Electrical Compliance Audit
December 04, 2007

Electrical Solutions Corporation
2368 Eastman Ave, Suite 13,
Ventura CA 93003

On December 4, 2007, Electrical Solutions conducted a field audit of the electrical installation at *location*. This audit focused primarily on physical construction and did not address any of the *design* issues which may need to be revisited. For example, we did not check breaker or conductor sizes for feeders or branch circuits. We did not check the breaker or overload trip settings for motors, or compare those settings with code requirements. And we did not check the conductor fill of electrical conduits or conduct any ampacity correction or derating calculations.

PV-V4 - (pic 3696)

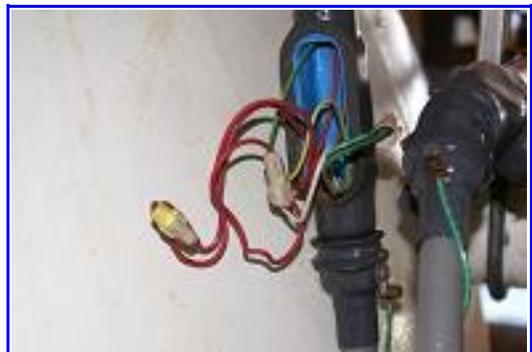
- Conduit body must be supported. [Article 314.23\(E\)](#).

Note: Sealtite cannot be used to support a conduit body, and if the nipple is considered to be the “support” for the conduit body, then it, in turn, would need to be rigidly supported (just like any other conduit).

V4 Micro Motion Transmitter - (pic 3699)

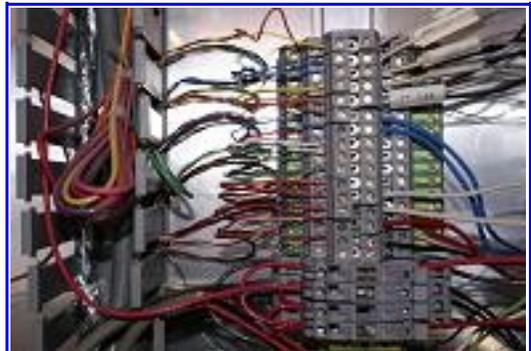
- Arcing device must have seals. [Article 501.15\(B\)\(1\).](#)
- Sealtite requires bonding jumper. [Article 501.30\(B\).](#)
- Arcing device should have an explosionproof union between the device and the seal to facilitate servicing.
-

V4 Alarm Panel - (pic 3702)

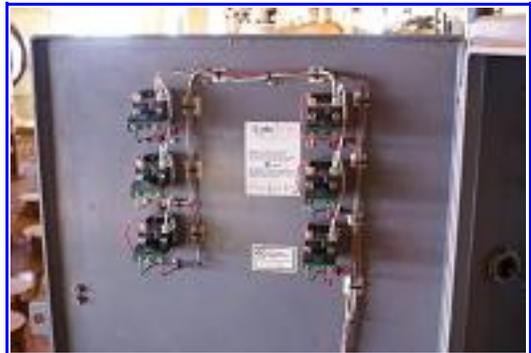
- Construction trash should be removed from the inside of the panel – bits of wire, insulation, paper, fiberglass dust, etc.

P3A / P3B Alarm Panel - (pic 3730)

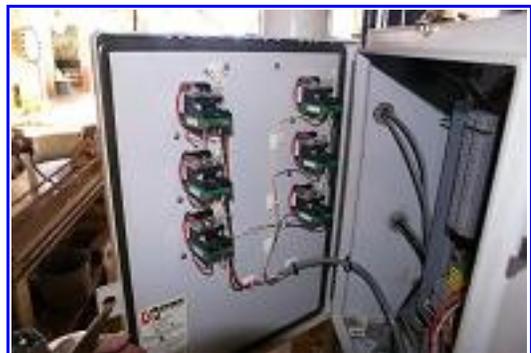
All comments from pics 3700 and 3701 apply here.

- Bond conduits and backpanel,
- Purge enclosure
- Terminate all wires
- Minimum wire size: #18 AWG
- Label all conductors
- Install shielded cable

V1 and V3 Alarm Panel - (pic 3741)

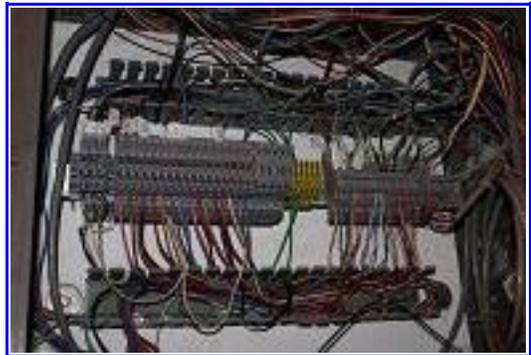
- Construction trash should be removed from the inside of the panel – bits of wire, insulation, paper, fiberglass dust, etc.

V1 and V3 Alarm Panel - (pic 3743)

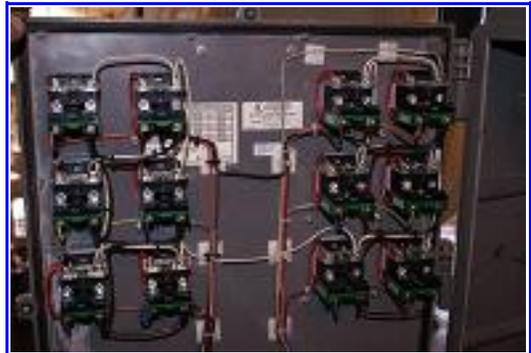
- Conductors should have labels identifying the source of supply.

Note: troubleshooting is extremely difficult when conductors are not properly identified. Identifying these conductors during the construction phase is much, much easier than during a dark and stormy night.

Electrical Enclosure near V33A - (pic 3785)

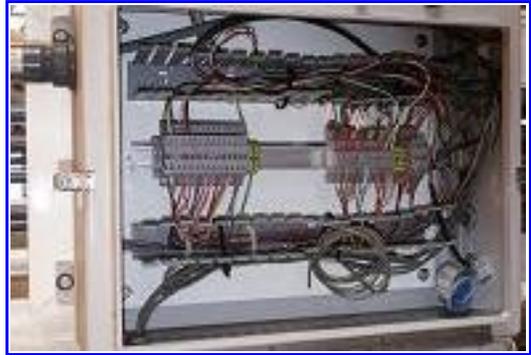
- Rigid conduit must be securely fastened within 3 ft of each enclosure, fitting and conduit body. [Article 344.30](#).
- Raceways cannot be used to support cables. [Article 300.11\(B\)](#).
- MC cable must be supported with 12 in of every cabinet. [Article 330.30](#).
- Cabinet should have an ID tag.

Electrical Enclosure near V33A - (pic 3787)

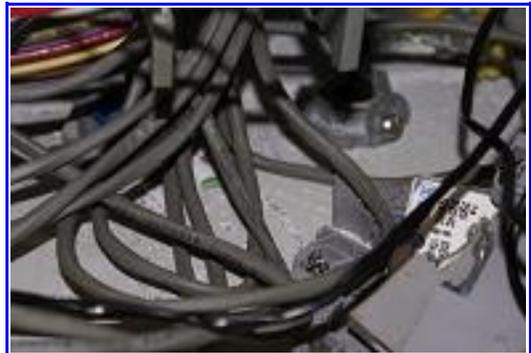
- Construction trash should be removed from the inside of the panel – bits of wire, insulation, paper, fiberglass dust, etc.

V14 Valve Switch - (pic 3791)

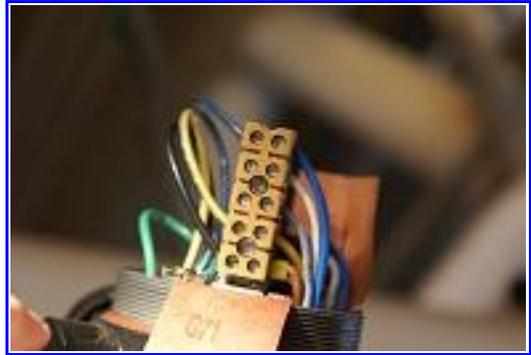
- Arcing device must have a seal. [Article 501.15\(B\)\(1\)](#).
- Arcing device should have an explosionproof union between the device and the seal to facilitate servicing.
